**IEEE P802.11
Wireless LANs**

Date: November 10, 1998

Author: Naftali Chayat
BreezeCOM
e-Mail: naftalic@breezecom.co.il

Proposed text corrections to a Draft 802.11a Standard, as approved by Nov 10, 1998, evening, [with additional suggested corrections by the author.](#)

Figure 11. Illustration of OFDM frame with cyclic extension and windowing

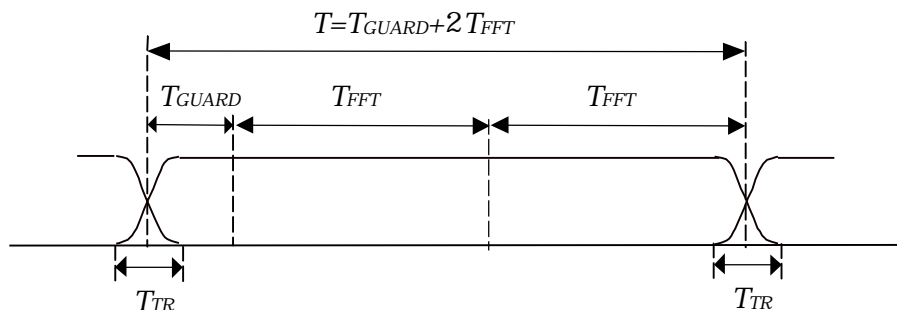
[insert fig 9 here as an illustration](#)
